RE: Nine Mile Point Unit 2 Docket No. 50-410 NPF-69

Subject: Conversion of the Nine Mile Point Unit 2 Current Technical Specifications to the Improved Technical Specifications (TAC No. MA3822)

SUMMARY OF CHANGES

Table 3.6.1.3-1 IABLE 3.6.1.2-1

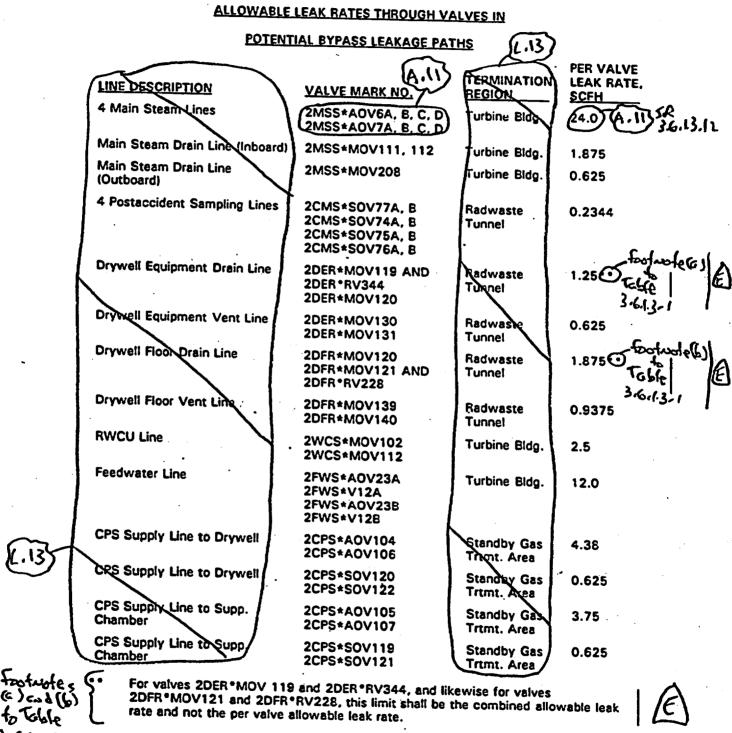
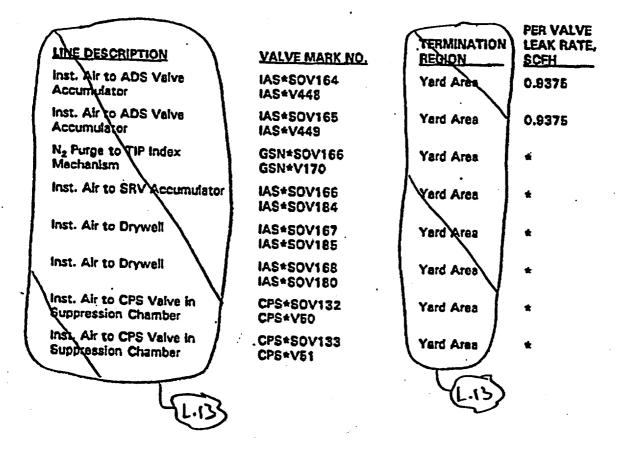
A license amendment (Amendment 88) received subsequent to the original ITS submittal added new valves and leakage limits to Current Technical Specification (CTS) Table 3.6.1.2-1, the Allowable Leak Rates Through Valves In Potential Bypass Leakage Paths Table. This change affects ITS 3.6.1.3, pages 3.6-22 and 3.6-23, the CTS markup for ITS 3.6.1.1, page 5 of 10, the CTS markup for ITS 3.6.1.3, pages 9 of 14 and 10 of 14, and the Improved Standard Technical Specification (ISTS) markup for ITS 3.6.1.3, insert pages 3.6-18a and 3.6-18b. In addition, it was noted that Revision D, which included changes based upon CTS Amendment 87, did not include a revised CTS markup page for Specification 3.6.1.1. This new CTS markup page does not technically change the submittal since the CTS page was being moved to another Specification, and the CTS page (as amended by Amendment 87) for the other Specification was included in Revision D. This change affects the CTS markup for ITS 3.6.1.1, page 6 of 10.
